Technical Service Bulletin

SUBJECT:		No: TSB-20-51-001	
UPDATES TO REAR WIPER AND WASHER INSPECTION - SMR		DATE: June 2020	
		MODEL: See below	
CIRCULATE TO:	<input type="checkbox"/> GENERAL MANAGER	<input checked="" type="checkbox"/> PARTS MANAGER	<input checked="" type="checkbox"/> TECHNICIAN
<input checked="" type="checkbox"/> SERVICE ADVISOR	<input checked="" type="checkbox"/> SERVICE MANAGER	<input type="checkbox"/> WARRANTY PROCESSOR	<input type="checkbox"/> SALES MANAGER

This TSB updates the Exterior section of the affected Service Manuals to add information to the Windshield Wiper and Washer Removal and Installation procedures. Please replace with the following pages.

51-57

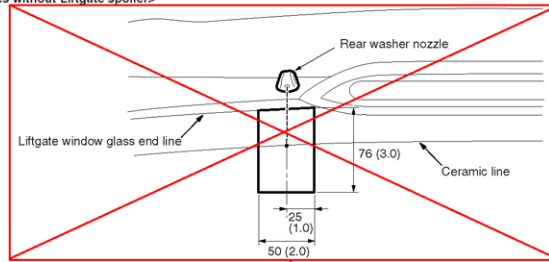
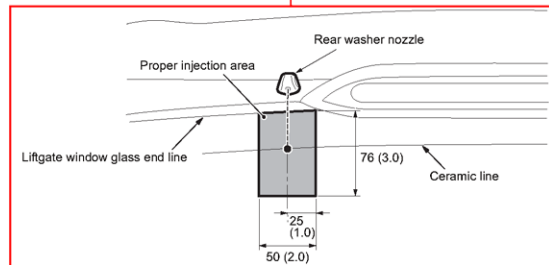
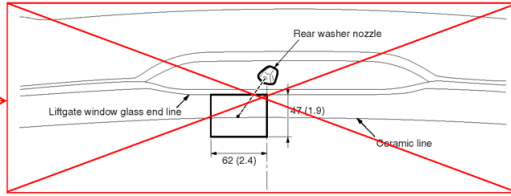
Please make the indicated changes to the 2014 Mirage Service Manual, Group 51-Exterior -> Windshield Wiper and Washer -> Removal and Installation.

2. Insert the jet type washer nozzle adjusting side of the special tool Adjustment tool, washer nozzle (MB992326) into the injection part of the washer nozzle as shown in figure (A).

3. Move the special tool Adjustment tool, washer nozzle (MB992326) up and down to adjust the angle of the washer nozzle as shown in figure (B).

<Incorrect>

<Correct>

51-58

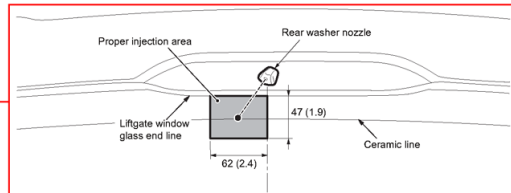
Please make the indicated changes to the 2014 Mirage Service Manual, Group 51-Exterior -> Windshield Wiper and Washer -> Removal and Installation.

The rear wiper and washer switch can be checked for proper operation by confirming ETACS diagnostic trouble code. (Refer to GROUP 54A - ETACS P.54A-231)

<Correct>

51-56

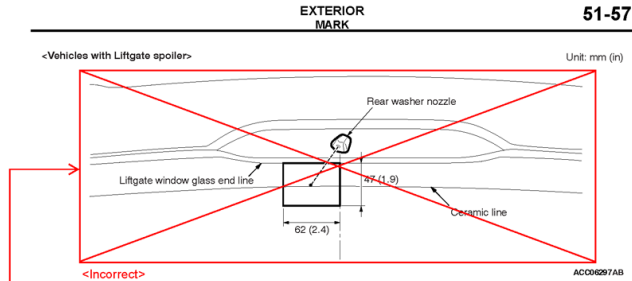
Please make the indicated changes to the 2015 Mirage Service Manual, Group 51-Exterior -> Windshield Wiper and Washer -> Removal and Installation.

2. Insert the jet type washer nozzle adjusting side of the special tool Adjustment tool, washer nozzle (MB992326) into the injection part of the washer nozzle as shown in figure (A).

3. Move the special tool Adjustment tool, washer nozzle (MB992326) up and down to adjust the angle of the washer nozzle as shown in figure (B).

<Correct>

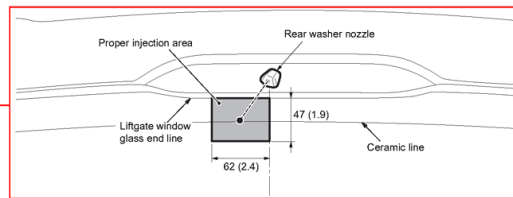
Please make the indicated changes to the 2015 Mirage Service Manual, Group 51-Exterior -> Windshield Wiper and Washer -> Removal and Installation.

The rear wiper and washer switch can be checked for proper operation by confirming ETACS diagnostic trouble code. (Refer to GROUP 54A - ETACS P.54A-218)

51-60

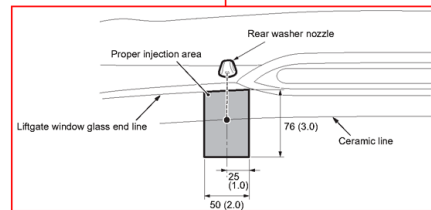
Please make the indicated changes to the 2017 Mirage Service Manual, Group 51-Exterior -> Windshield Wiper and Washer -> Removal and Installation.

2. Insert the jet type washer nozzle adjusting side of the special tool Adjustment tool, washer nozzle (MB992326) into the injection part of the washer nozzle as shown in figure (A).

3. Move the special tool Adjustment tool, washer nozzle (MB992326) up and down to adjust the angle of the washer nozzle as shown in figure (B).

<Correct>

51-61

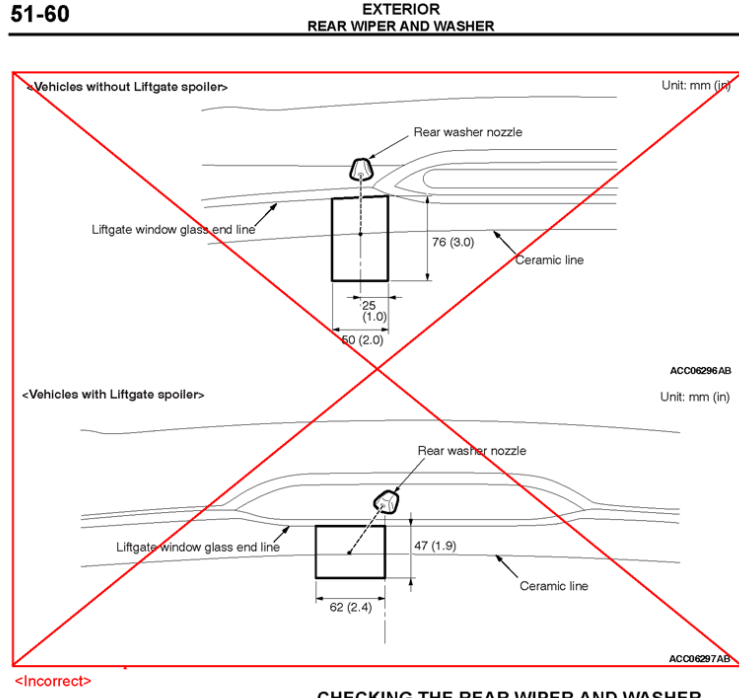
Please make the indicated changes to the 2017 Mirage Service Manual, Group 51-Exterior -> Windshield Wiper and Washer -> Removal and Installation.

The rear wiper and washer switch can be checked for proper operation by confirming ETACS diagnostic trouble code. (Refer to GROUP 54A - ETACS P.54A-246)

<Correct>

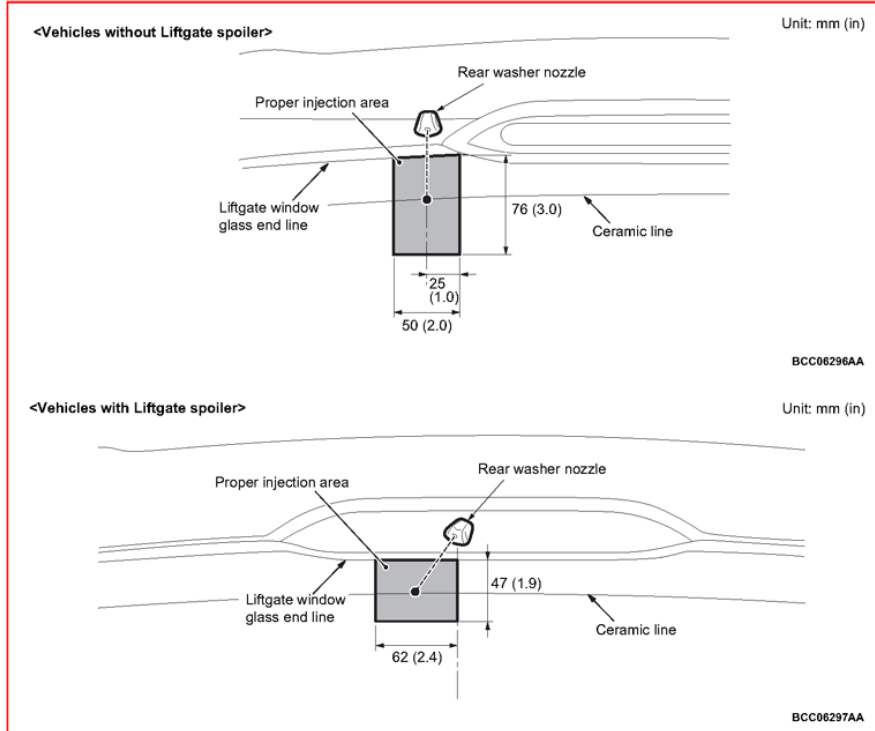
Please make the indicated changes to the 2018 Mirage Service Manual, Group 51-Exterior -> Windshield Wiper and Washer -> Removal and Installation.

The rear wiper and washer switch can be checked for proper operation by confirming ETACS diagnostic trouble code. (Refer to GROUP 54A - ETACS [P.54A-279](#))

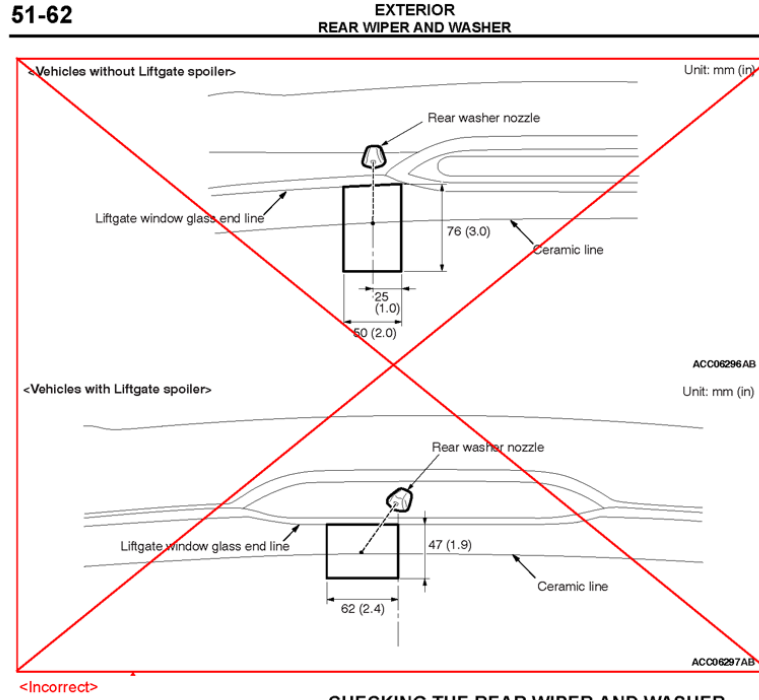
Please make the indicated changes to the 2018 Mirage Service Manual, Group 51-Exterior -> Windshield Wiper and Washer -> Removal and Installation.

<Correct>

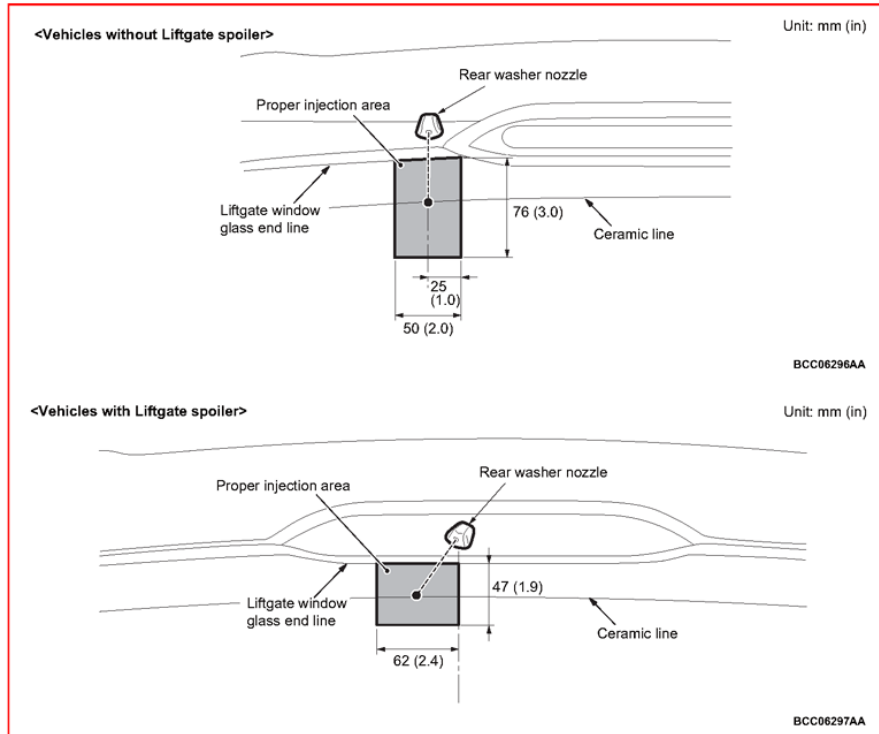
Please make the indicated changes to the 2019 Mirage Service Manual, Group 51-Exterior -> Windshield Wiper and Washer -> Removal and Installation.

The rear wiper and washer switch can be checked for proper operation by confirming ETACS diagnostic trouble code. (Refer to GROUP 54A - ETACS [P.54A-281](#))

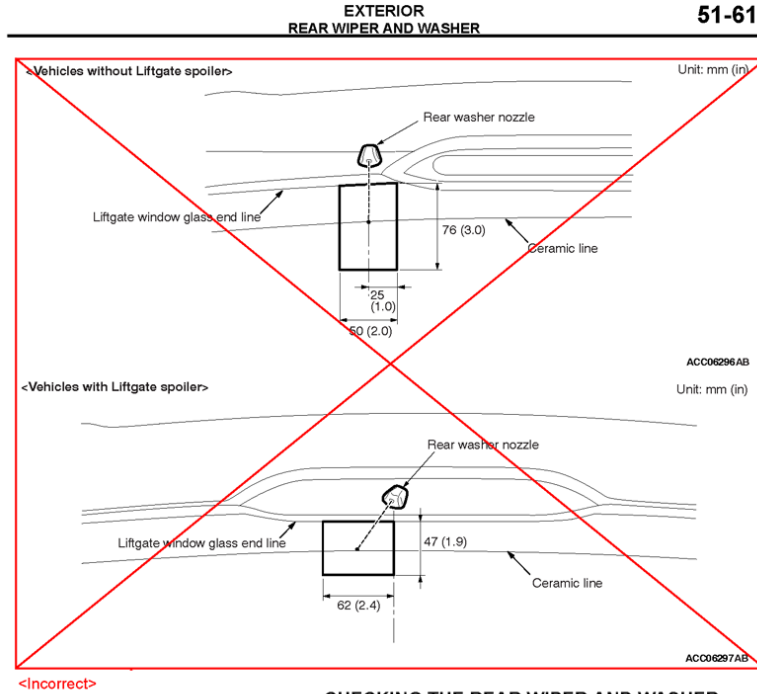
Please make the indicated changes to the 2019 Mirage Service Manual, Group 51-Exterior -> Windshield Wiper and Washer -> Removal and Installation.

<Correct>

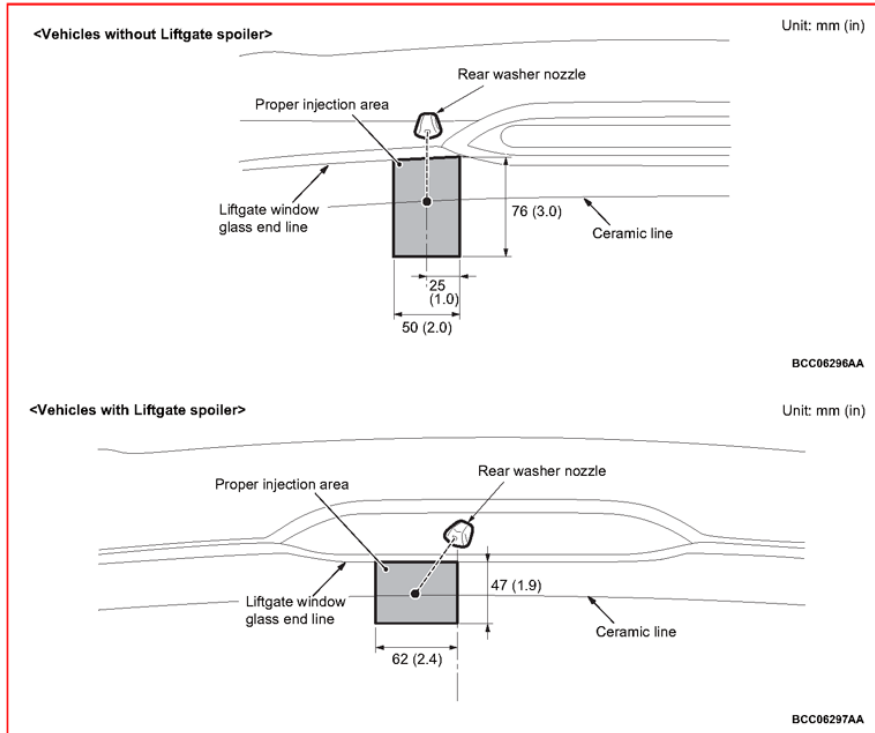
Please make the indicated changes to the 2020 Mirage Service Manual, Group 51-Exterior -> Windshield Wiper and Washer -> Removal and Installation.

The rear wiper and washer switch can be checked for proper operation by confirming ETACS diagnostic trouble code. (Refer to GROUP 54A - ETACS P.54A-281)
